Re: Wickersham and Oltorf Project

I am writing on behalf of the Monaco community association in follow up to our zoom meeting and in reply to your client's concept plan proposal. The association appreciate the revised plan but is not amenable to the proposal.

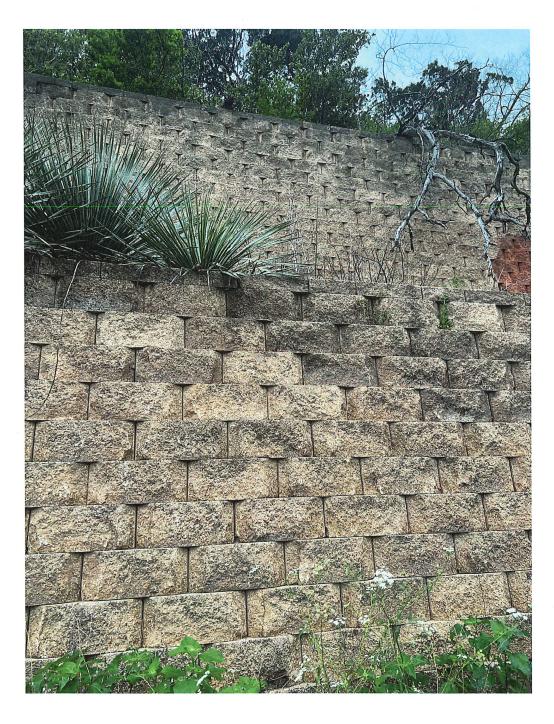
This wall on Bee Caves Road is similar to the scale that Mr. Patel proposes to build. Counting all terraces this wall is approximately 21' tall – equivalent to or smaller than the wall Mr. Patel proposes to build. So the Monaco neighbors will be looking at this, *plus* 18' more in the form of

the building on top of it:

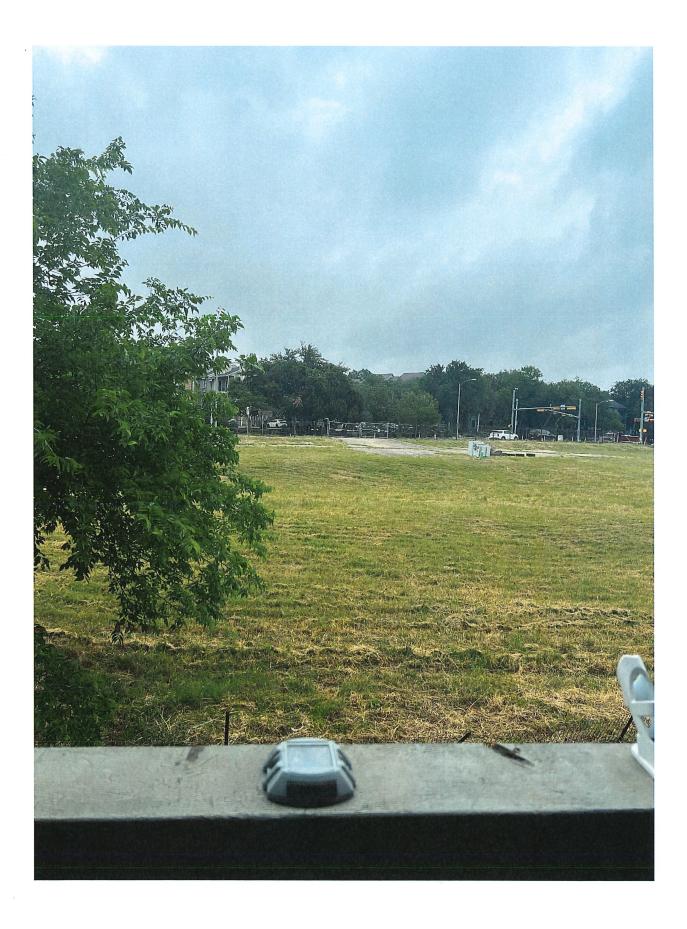
Monaco's suggestion is as follows, and involves creating a development more harmonious and organic with the land that does require massive amounts of cut and fill that will put Monaco residents in a hole, requiring owners on both stories to look directly and only at a towering retaining wall:

- 1. Eliminate the immediate access points adjacent to Wickersham as proposed and slope the driveway from Wickersham at a grade near 9% to reduce the height of walls along the HOA property line as shown on the attached marked up exhibit. Have parking along the joint property line to provide the required parking for the development, with a short fence/wall (5-6') for mutual privacy.
- 2. The proposed grading concept will lower the pond and site significantly from what Mr. Patel has proposed, which will reduce the height of the walls.
- 3. The HOA is amenable to and would far prefer that Mr. Patel pipe the pond outfall between its buildings to minimize drainage concerns and impact to adjacent building. Under the proposed plan the outfall will spill over into HOA property and create runoff over their land and between the buildings.
